CERTIFICATE OF APPROPRIATENESS

Property: 501 Heights Boulevard, lot 12, block 291, Houston Heights Subdivision. The property includes a historic 1,689 square foot, one-story wood frame single-family residence situated on a 5,900 square foot (50' x 118') corner lot.

Proposal: Alteration – Door

FRONT DOOR

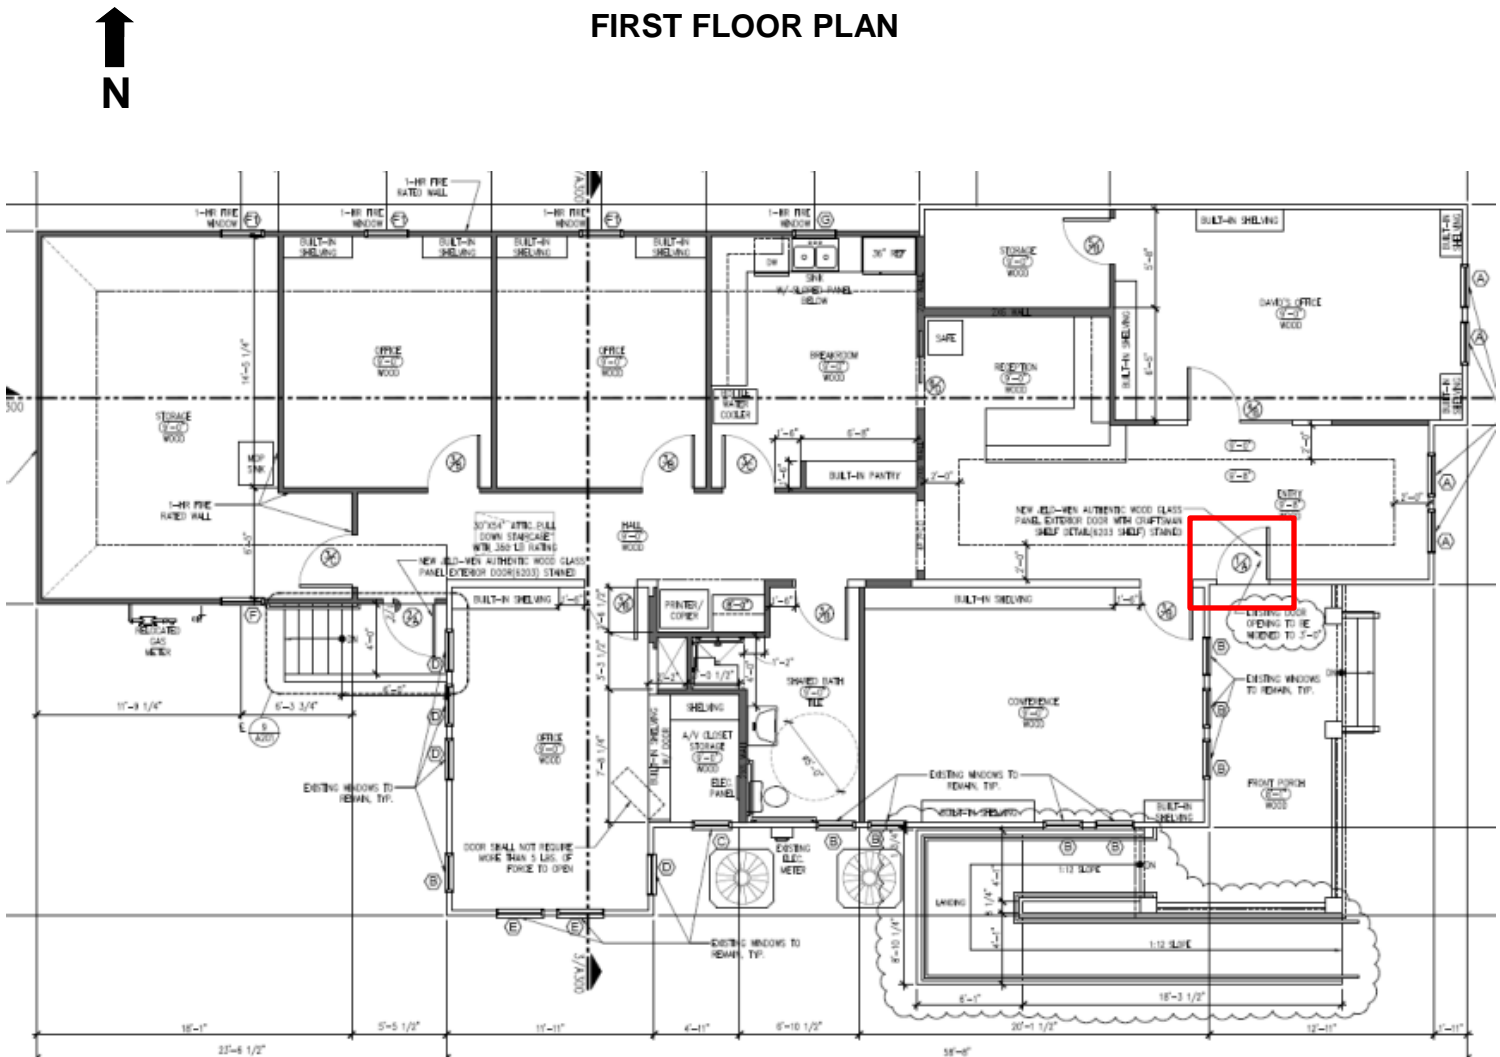
- Widen the front door opening from 2'-8" wide by 6'-8" tall to 3' wide by 6'-8" tall so the door opening will be in compliance with ADA guidelines.
- Replace non-original door with a craftsman-style door.
- Replace non-original trim around door opening with similar style trim that is present.

S	D	NA		S - satisfies	D - does not satisfy	NA - not applicable
<input checked="" type="checkbox"/>	<input type="checkbox"/>	<input type="checkbox"/>	(1)	The proposed activity must retain and preserve the historical character of the property; <i>Generally, altering original openings is not appropriate. However, staff is in support of widening the door opening for ADA access since minimal historic material will be lost and the current front door is not original. The new proposed door for the opening is compatible.</i>		
<input checked="" type="checkbox"/>	<input type="checkbox"/>	<input type="checkbox"/>	(2)	The proposed activity must contribute to the continued availability of the property for a contemporary use;		
<input checked="" type="checkbox"/>	<input type="checkbox"/>	<input type="checkbox"/>	(3)	The proposed activity must recognize the building, structure, object or site as a product of its own time and avoid alterations that seek to create an earlier or later appearance;

Recommendation: Approval
